COMMENTS AND RESPONSES ON DEIR

North Beach Public Library and Joe DiMaggio Playground Master Plan Project

PLANNING DEPARTMENT
CASE NO. **2008.0968E**

Re: **Attached Comments and Responses on Draft Environmental Impact Report
Case No. 2008.0968E North Beach Public Library and Joe DiMaggio
Playground Master Plan Project**

Figure C&R-2
Park Use Area Calculations

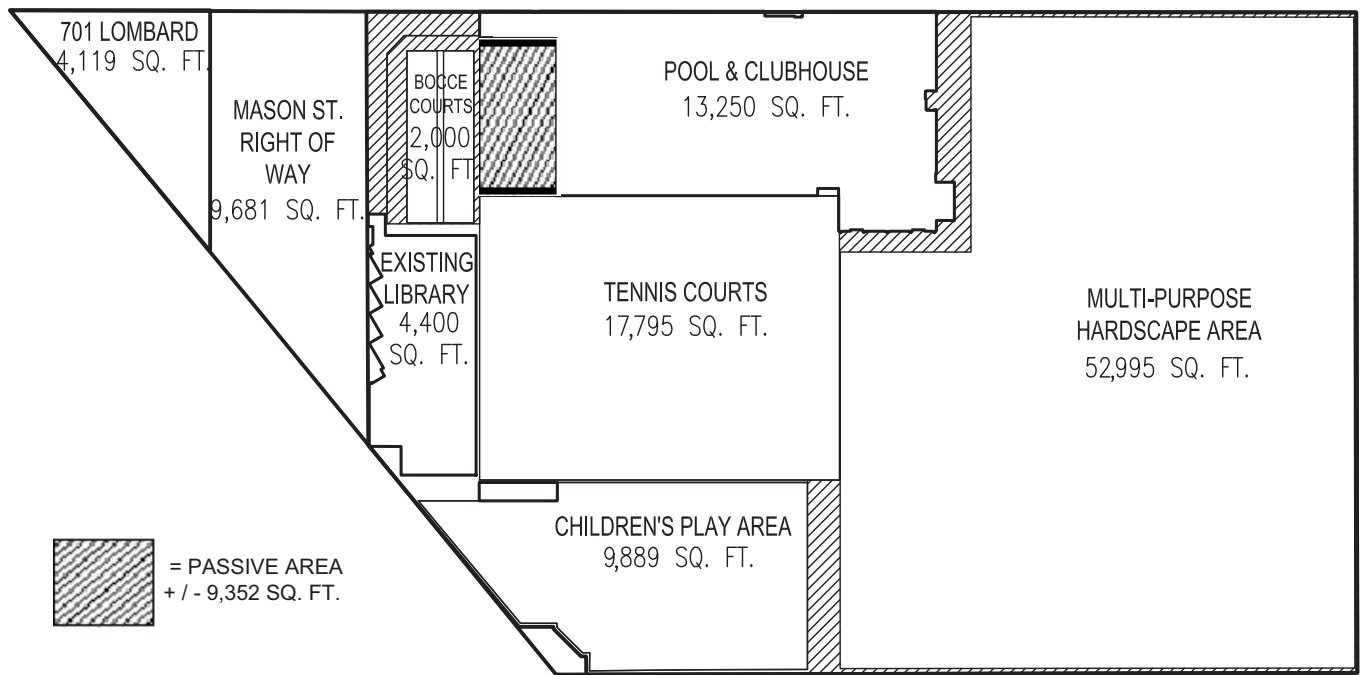
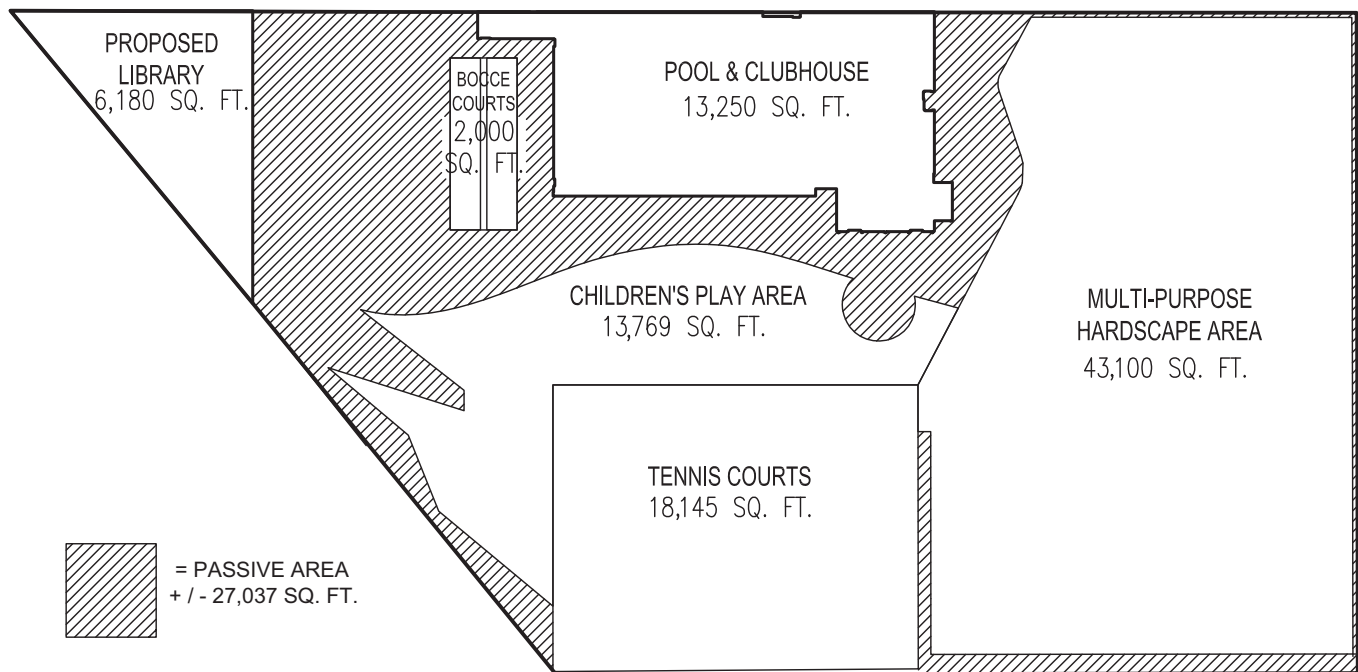
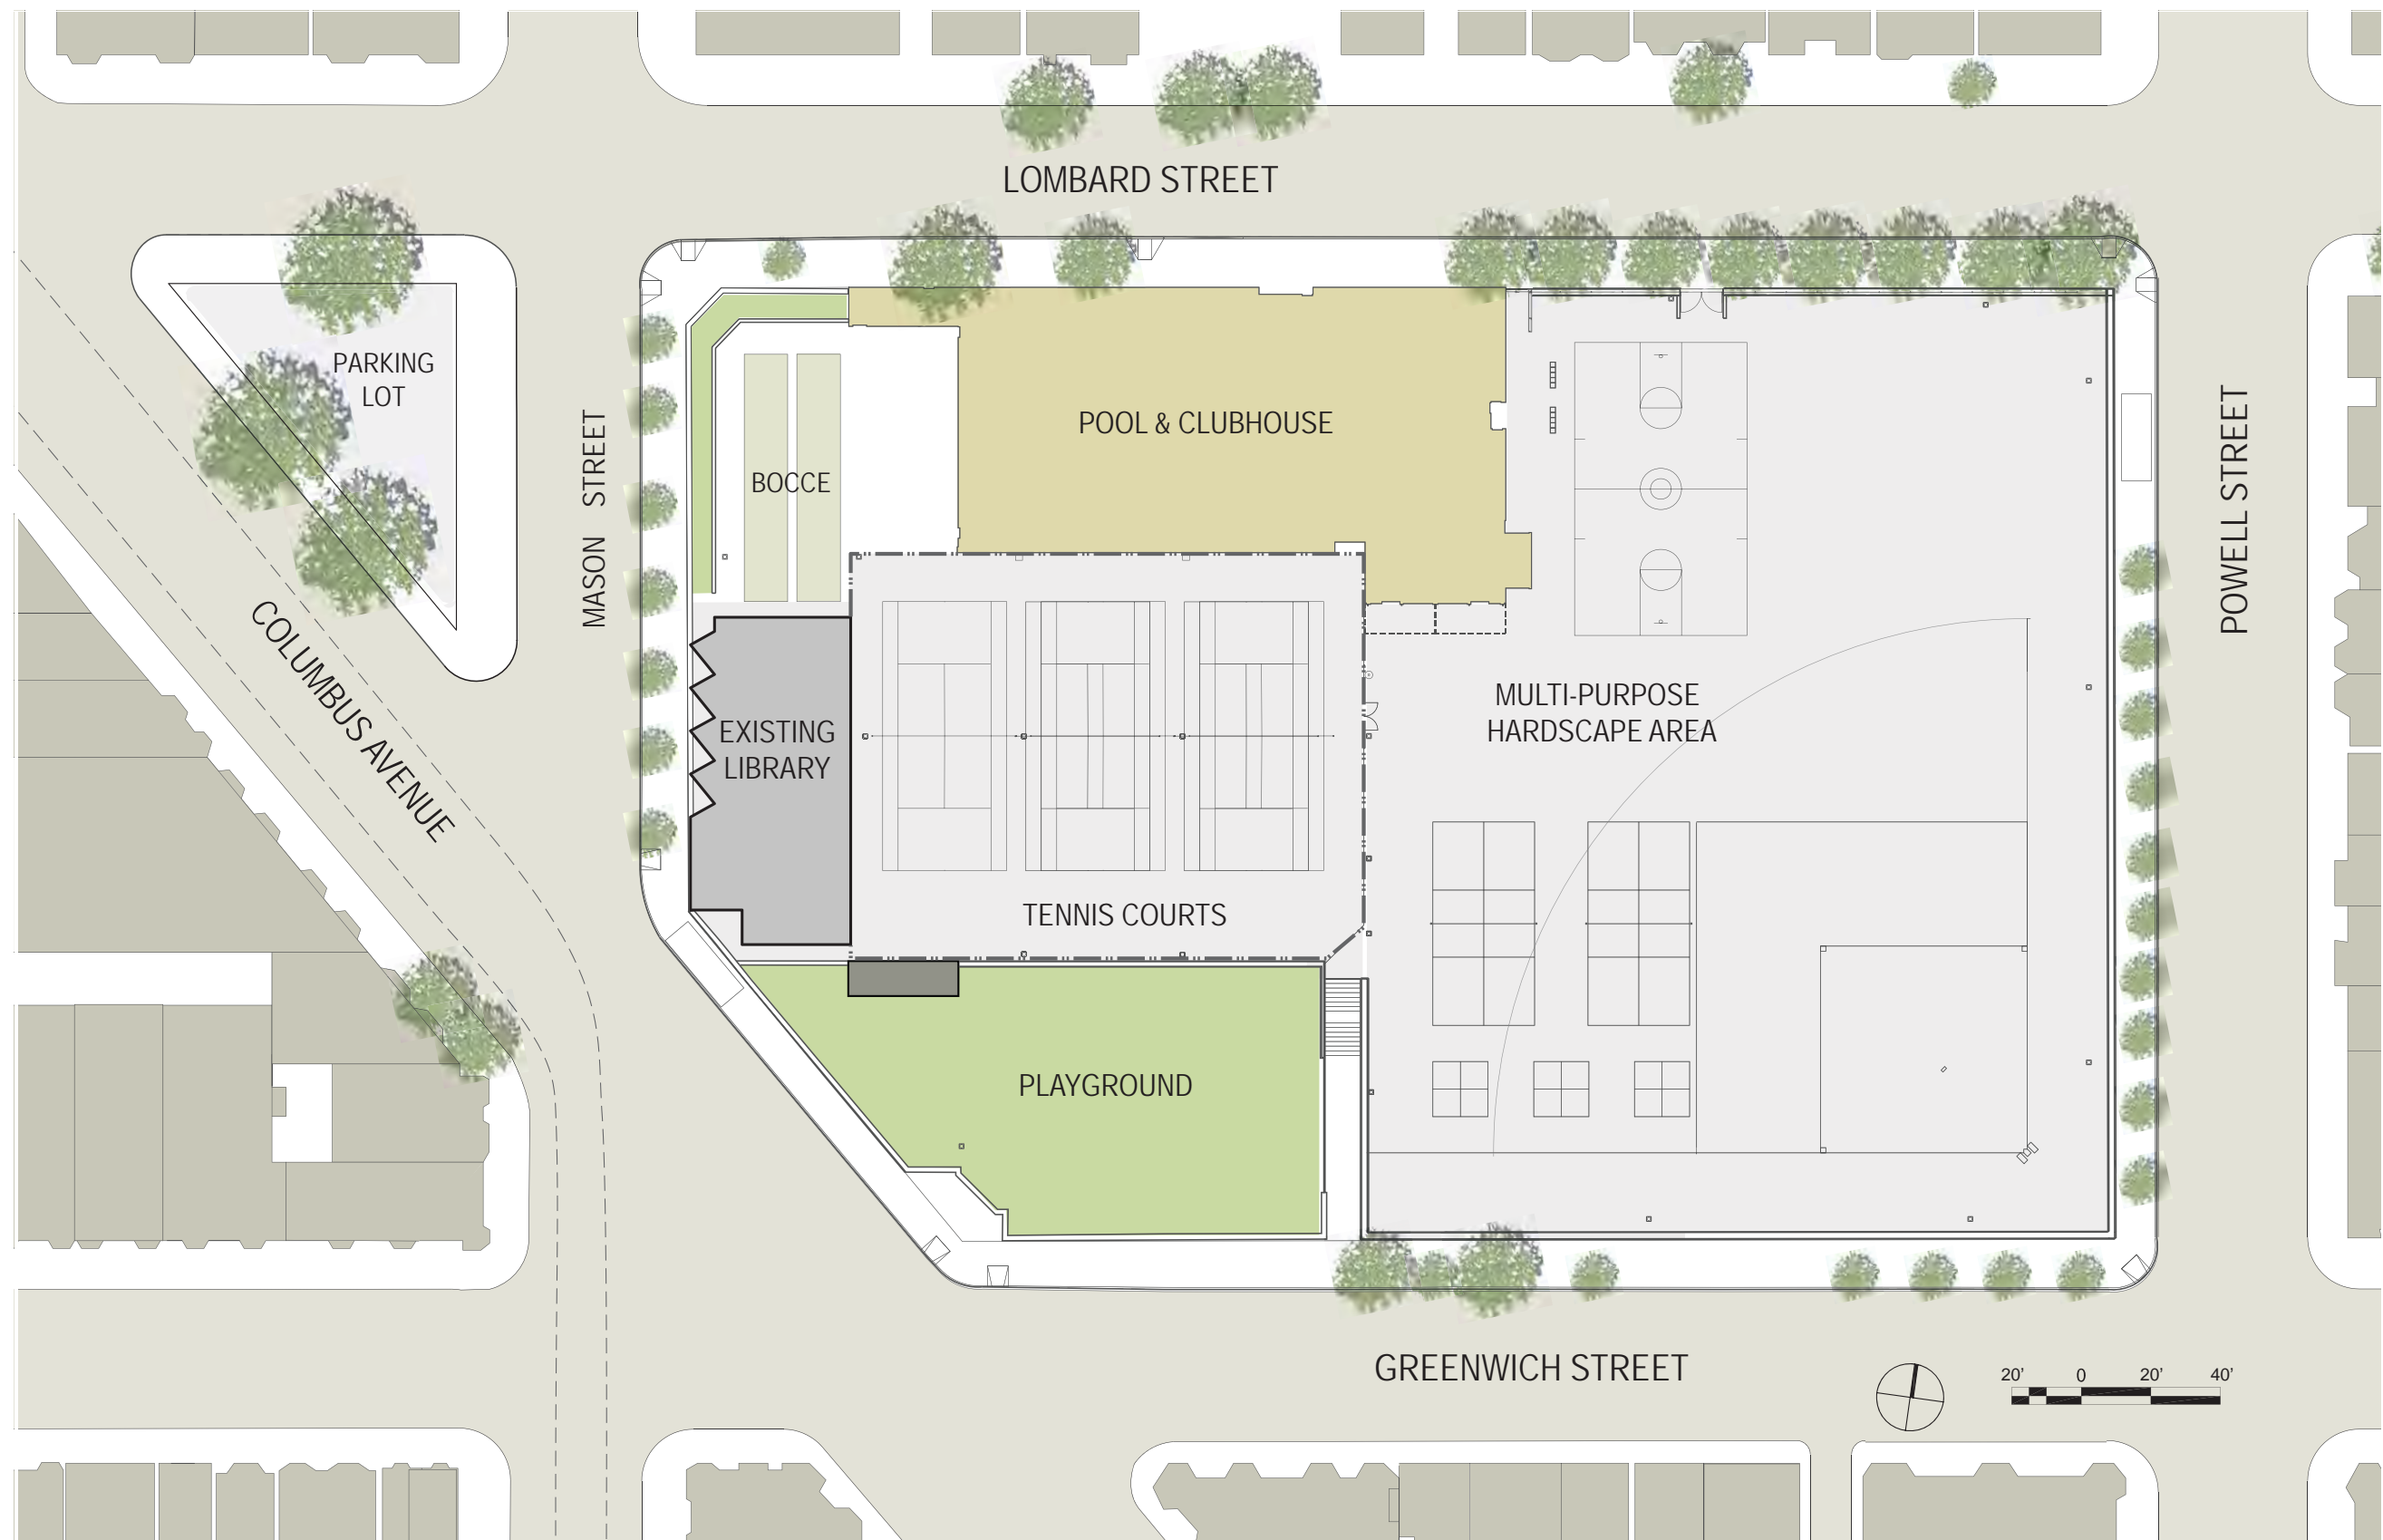
“In spite of its claims that the proposed project would add a new 12,000 square feet of new open space and a new 13,700 sq foot children’s play area, the DEIR contains no accurate description or clear comparison of existing and proposed dimensions and square footage of the individual outdoor recreation spaces. A clear comparison of the existing and proposed dimensions and square feet for each of the individual outdoor recreation spaces must be set forth and clearly shown on Figure 3 (Existing Conditions) and Figure 8 (Master Plan Phase No. 2). However, the scale of these two figures is different in the DEIR making comparison between them difficult.

- (a) Make the scale of Figures 3 and 8 the same and set forth on these figures the exact dimensions and square feet of each of the following features in their Existing and Master Plan Phase 2 conditions:
 - (1) Multipurpose Hardscape Area
 - (2) Tennis Courts
 - (3) Children’s Play Area
 - (4) Bocce ball courts
 - (5) Undeveloped area of Mason Street
 - (6) Footprints of existing and proposed library
- (b) Show on Figure 8 exactly where the ‘new, approximately 13,700 sq foot play area would be constructed in the center of the block.’ (Pg 45)
- (c) Show on Figure 8 all the new fenced area that would be located within the boundaries of the playground for the (1) the multipurpose hardscape area, (2) the tennis courts, (3) the children’s play area, and (4) the bocce ball courts. ...

- (a) Showing on Figures 3 and 8 (using the same scale) the exact dimensions and square feet of each of the following features in their Existing Condition and Master Plan Phase 2 conditions:
 - (1) Multipurpose Hardscape Area
 - (2) Tennis Courts
 - (3) Children’s Play Area
 - (4) Bocce ball courts
 - (5) Undeveloped area of Mason Street
 - (6) Footprints of existing and proposed library

- (b) Including on Figure 8 the exterior boundaries of the new 13,700 sq foot children's play area.
- (c) Including on Figure 8 all the new fences that would be located within the boundaries of the playground to separate the children's play area from the multipurpose hardscape area and from the bocce courts.
- (d) Including an estimate of the total square footage of walkways and ramps within the 13,800 sq ft of proposed new children's play area.
- (e) Is the Bocce Court area included within the 13,800 sq ft of new children's play area?" (*Vedica Puri, Letter, October 12, 2010*)

Figure C&R-2 provides a direct comparison of individual playground programmatic elements and their measurements. Please note that these figures are estimates, and measurements in **Figure C&R-2** are based on the proposed Master Plan. Measurements within **Figure C&R-2** are also in **Table C&R-1**. When and if funds are identified for the implementation of phase two of the Master Plan, the design would be refined and exact dimensions would be determined.

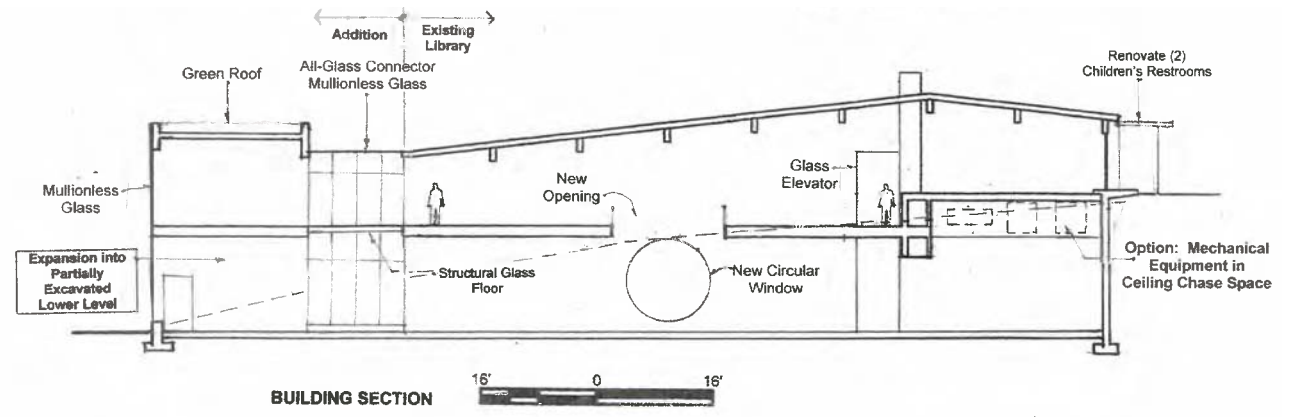
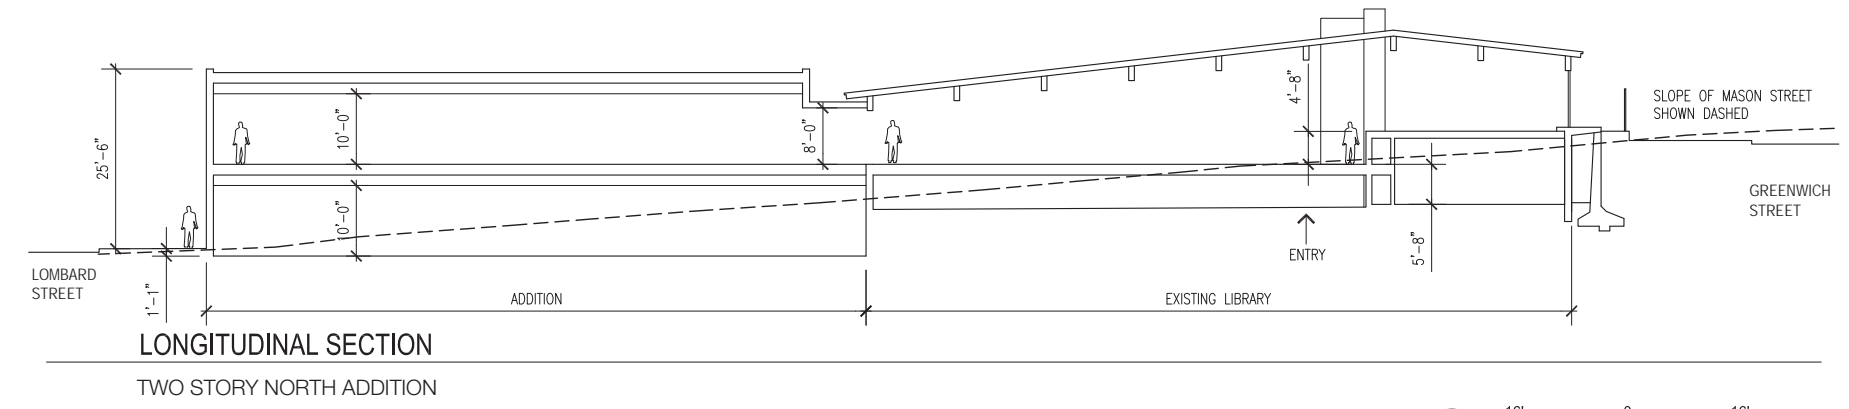
“The alternatives considered do not appear to include one that has been repeatedly promulgated by a neighborhood group, Friends of Appleton and Wolfard libraries, and was part of the architect’s plan, according to one attendee at public meetings on North Beach landmarking: Zach Stewart: scooping out space beneath the existing footprint.

“We understand that a letter from S. F. Architectural Heritage provides some successful examples of such below-ground additions at two other U.S. libraries, Columbia University and L.A. Public Library. We note that San Francisco Public Library certainly would know about this possibility from its own renovation experience—the Noe Valley Branch renovation, which was completed about three years ago, included addition of space within the existing footprint by scooping out space in the lower level for such things as new and spacious rest rooms, elevator, telecom closet, and related access.” (*Peter Warfield, Executive Director, Library Users Association, E-mail, October 12, 2010*)

The commenters generally suggest, or specifically provide, additional alternative designs for analysis in the EIR, including an eastward expansion alternative and/or a subterranean expansion alternative.

Figure 27 (Revised)
Looking Southward on Mason Street from Bay Street

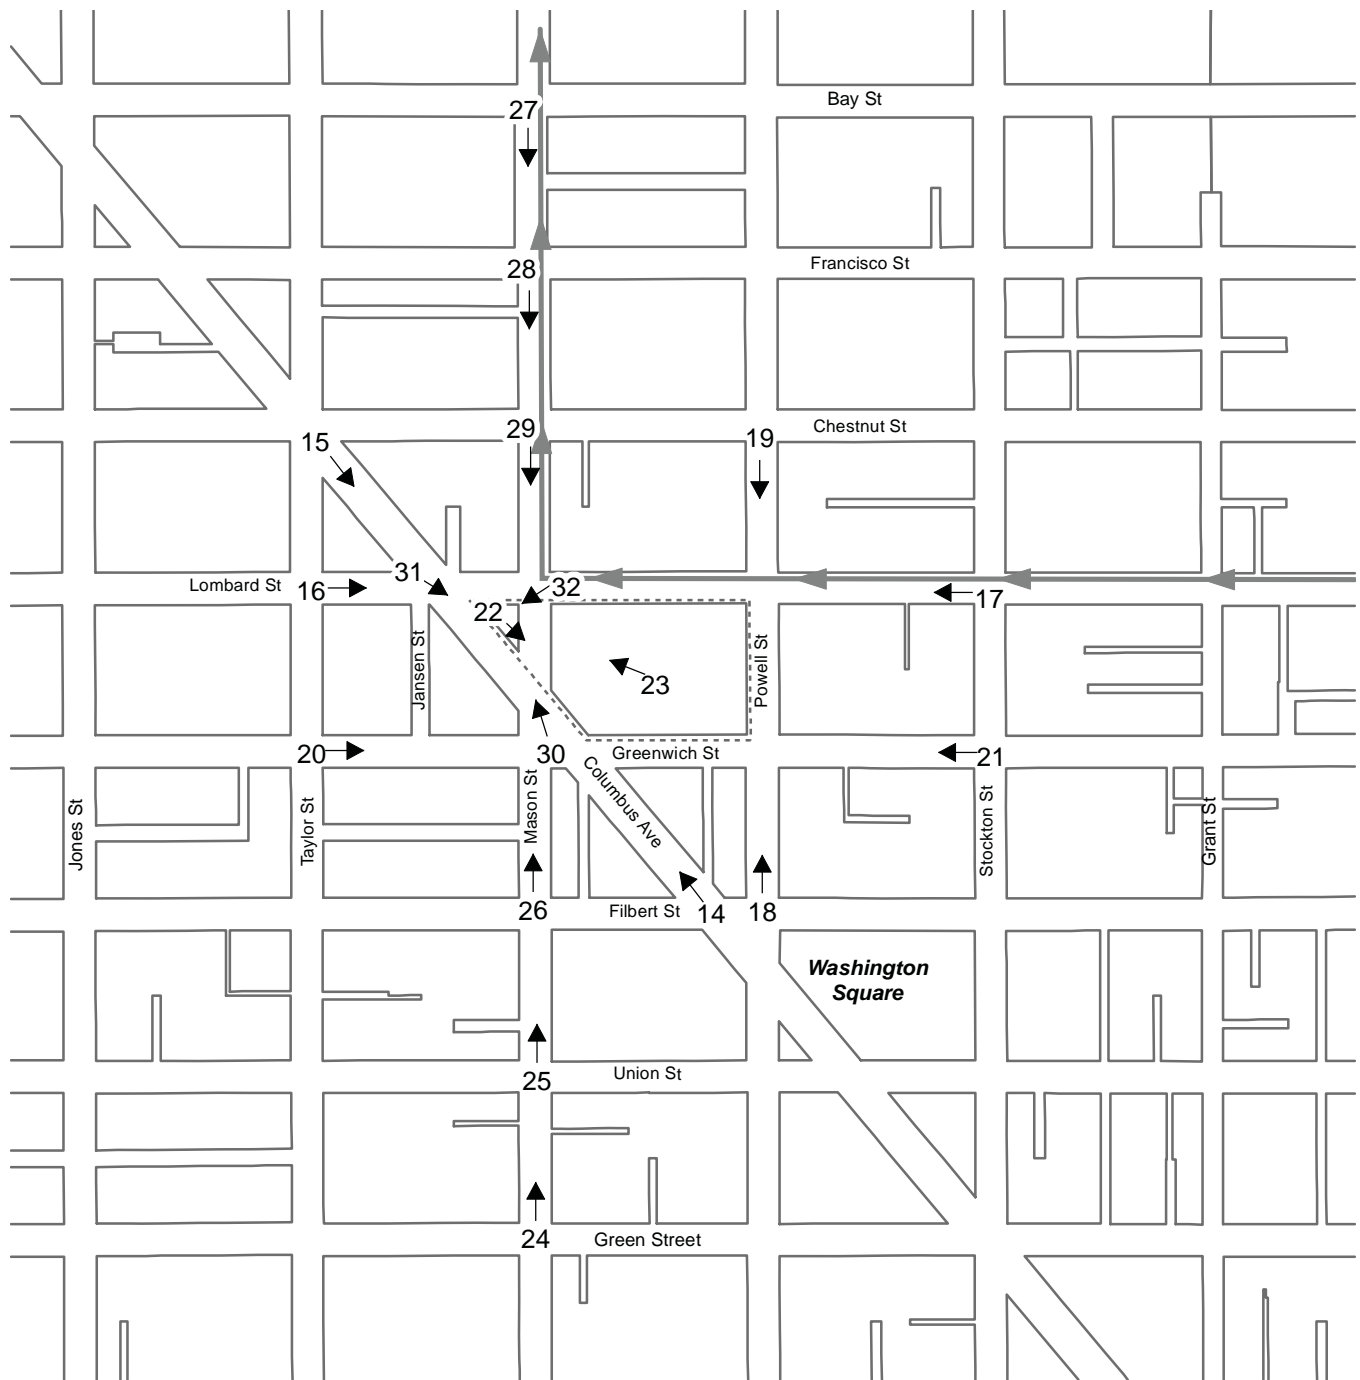
negative, especially for those residents within close proximity to the building. Nonetheless, established focal points and views of scenic resources in the distance would continue to be available, and the impact would be less than significant. Please see Section D of this document, which includes a revised version of Figure 27, p. C&R-203, that places the potential landscaping of the Mason Street right-of-way in the correct location.

On page 118, the bottom image in Figure 27 is replaced to accurately convey the type and character of landscaping that could be included within the Mason Street right-of-way under the proposed project. Please see Revised Figure 27 on the following page.
